RIVER HEIGHTS CITY PLANNING COMMISSION AGENDA

**RE: Conservice Preliminary Design
Review Comments**

CONSERVIVE BUILDING
COMMERCIAL DEVELOPMENT
RIVER HEIGHTS CITY - PRELIMINARY
LAYOUT SUBMITTAL

See attached wall section showing building height.

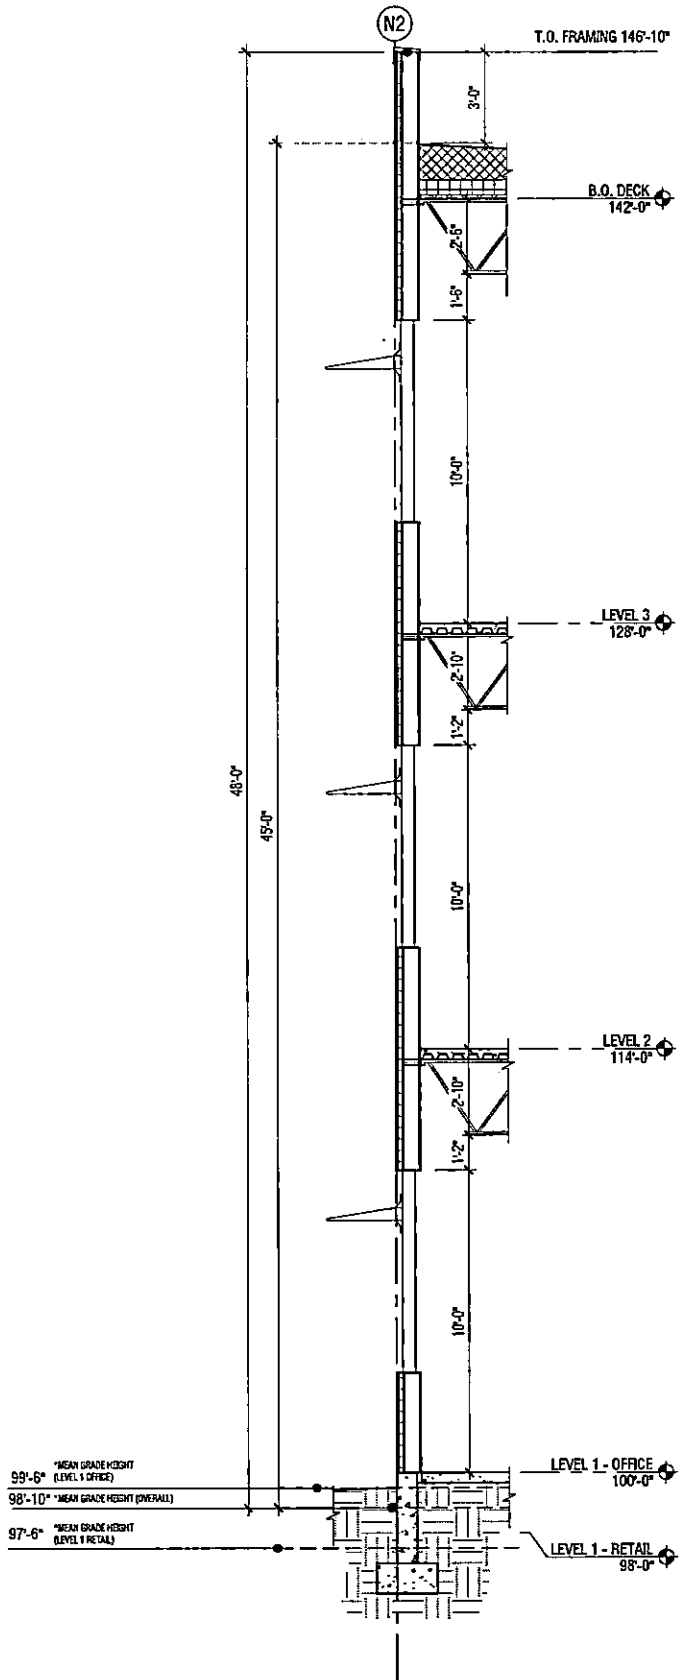
The diagram does not dimension from B.O. Deck (Bottom of roof deck) to the top of roof surface where the height limitation is measured. This dimension is 1'-10" by my calculations. Within this distance is the roof deck, rigid insulation, and tapered insulation to account for the roof slope.

The roof deck is usually 1.5", the rigid insulation can be up to 6" but is generally 4", that leaves approximately 1'-2" to 1'-4" for the tapered insulation system to accommodate roof drainage. Given the scenario presented in the wall section, it is my opinion that 45 feet should be adequate. The developer may have further discussion at the Planning Commission meeting.

As discussed on the phone previous, for a commercial application, T.O. Roof, is to T.O. Membrane, not including parapets. Per your discussions with the Wasatch Group the parapets would be minimal, 3 feet, enough to screen any R.T.U.'s.

I have attached a section showing our understanding of the overall mean grade height. I calculated the Overall Mean Grade height to be 98'-10". Two-thirds of the building perimeter grade height is at 99'-6" and the other one-third is at 97'-6". Taking 2/3 of the 2'-0" is 1'-4". So the Overall Mean Grade, not taking into consideration slab elevations, is 98'-10". If slab elevations can be taken into consideration the Overall Mean Grade height could increase, due to the fact that the exterior slab elevations are essentially level with the floors and then slope away from the building.

At the current calculated Overall Mean Grade of 98'-10", we are at 45'-0" to T.O. Membrane. We are currently in SD with schematic information from Structural and Mechanical. This height could vary up and down depending on the depth of structure, depth of tapered insulation and location/quantity of roof drains and more. We would feel more comfortable if we had a contingency in the height. Instead of asking for 45'-0" above grade, we would like to propose asking for a height of 46'-0". Can you pass this information to Rex D. and the council to see what their initial thoughts would be on the height request?

EAST ELEVATION

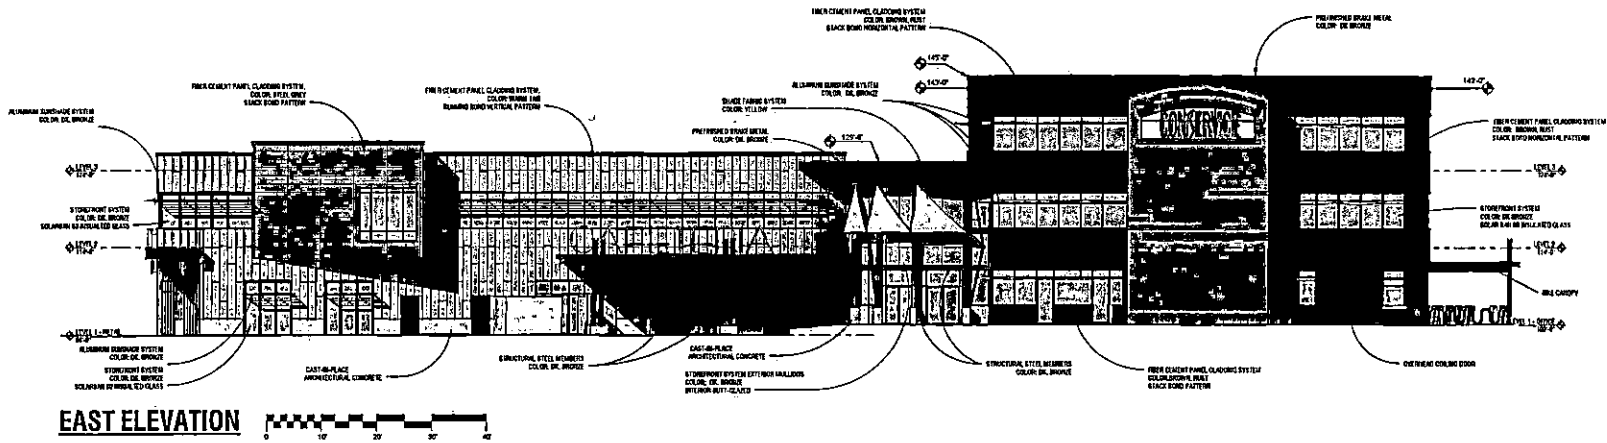
13. Site lighting is not shown on the layout plan. A site lighting plan is required to verify lighting requirements.
14. The east building elevation shows covered bicycle parking, however the number of fixed parking stalls is not shown/called out. Ordinance requires one fixed bicycle parking location for each 10 parking stalls. Verify the number of bicycle parking locations and specify on the site plan.

OVERALL SITE PLAN

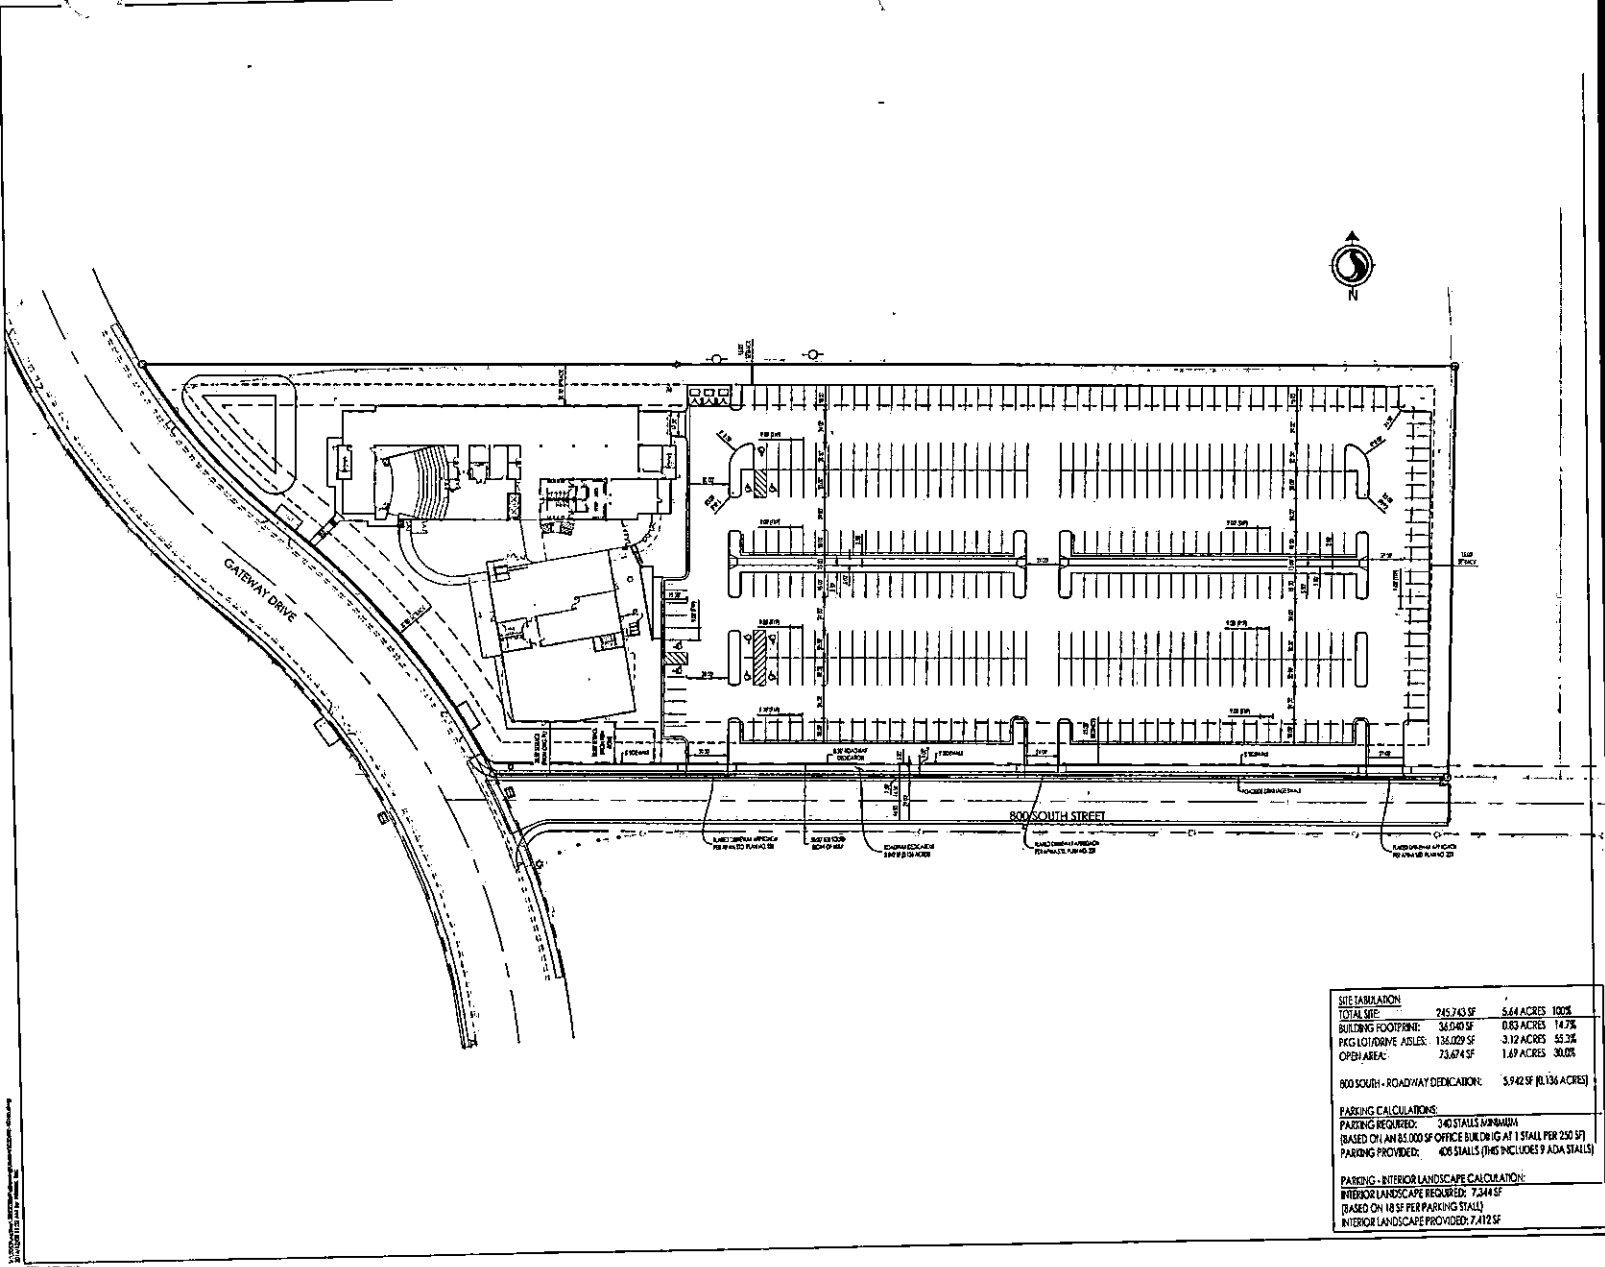
1. Radii for back of curb should be called out at the 800 S – 100 E intersection.
2. The curb/sidewalk radius on the north side of 800 South at 100 East appears to require a radius or chamfer on the property line dedication. The back of curb radius on the north side should be a minimum of 25 feet. Recommend that the 30 foot setback remain as shown with the corner “squared off” parallel to the respective streets.
3. 800 South intersects 100 East at an acute angle. Per City Ordinance 11-6-3 K. the south side back of curb radius should be 40 feet.
4. Site plan should show the two curb cut access locations onto 100 East as to be removed.

5. The plan shows dimensions for the 800 South street section. However it is difficult to see where some of the dimensions fall. The north side planter between the back of curb and sidewalk should be five feet. It appears the dimensions may indicate a 4.5 foot wide planter. Please provide a cross section of 800 South street improvements.

6. City ordinance requires a minimum 3 foot wide planter area around the building except at entrances and service areas. The site plan indicates that there is hard surfacing adjacent to the building on all but the north side.

7. Street and access signage are not indicated on the plan. This item can be coordinated on the final design documents.
8. The parking lot ordinance required that each parking aisle be bounded by landscaped islands. The parking lot layout should be adjusted accordingly.

9. The north-south center access aisle in the parking lot is 24 feet wide, face of curb to face of curb. The center access to 800 South is dimensioned as 24 feet from face of curb, however, there is a gutter on the south side of the access that limits asphalt width to 22 feet. The gutter is typically not included in the travel way, Developer/Engineer should verify that this is the desired intent to have a narrower access.

10. The site plan should callout or show details for how the north and east property line will be addressed. Is there a retaining wall along part of the property, what fencing provisions are proposed, etc.

11. Per the floor areas listed on the architectural floor plan sheets, the total building square footage is approximately 87,200 square feet. Based on this area, the minimum number of parking stalls is 348 instead of the 340 indicated. (Does not change site plan, update calculations.)

12. Verify that the center sidewalk in the parking lot is not included in the area for interior parking lot landscaping. Provide verification of area calculations for interior landscaping.

15. The landscape plan shows parking shade structures along the central island of the parking lot. These are not indicated on the site plan. Elevations and or sections of parking shade structures should be provided and the location should be indicated on the site plan if they are proposed for construction.
